CITY OF ALBUQUERQUE

RE: Lot 8 Block 3 Unit 19, S.A.D. 228
Volcano Cliffs Subdivision
7809 Urraca Rd. NW
Grading and Drainage Plan
Engineers Stamp Date 4/13/2021 Rev (D10D003U8)

DRAINAGE PLAN

NIETO, PETER (PAULA PEREZ) - G & D PLAN

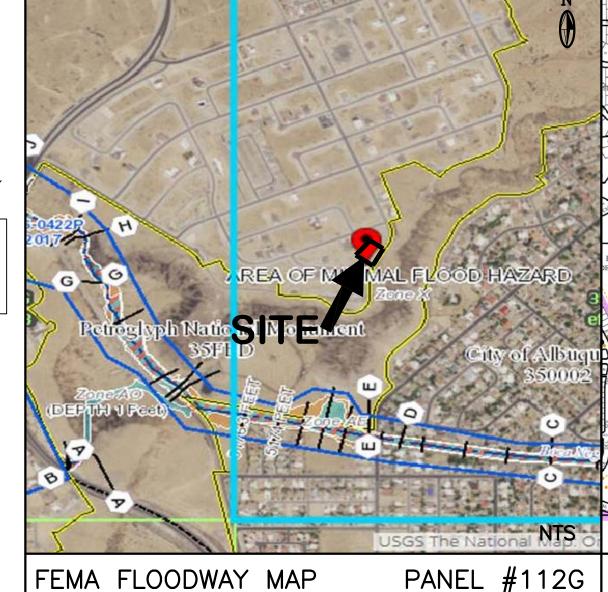
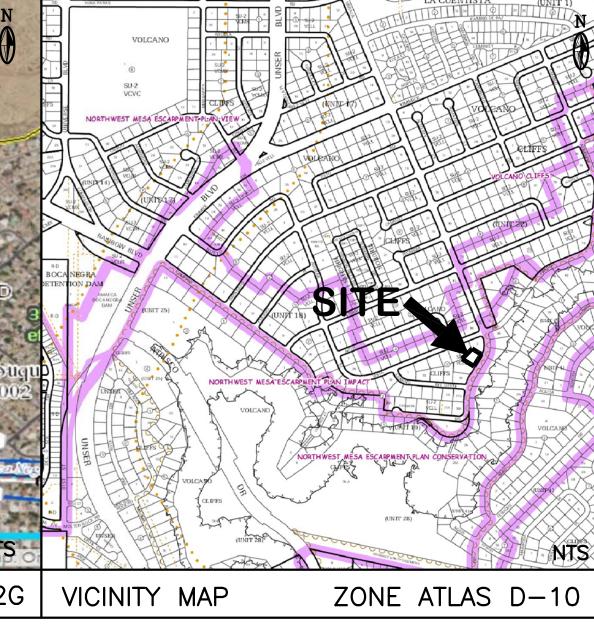
This is the plan to be used for any garden walls and any openings in the walls shall be placed 3" above final grade in the rear yard to allow for cross lot drainage from west to east (upstream to downstream).
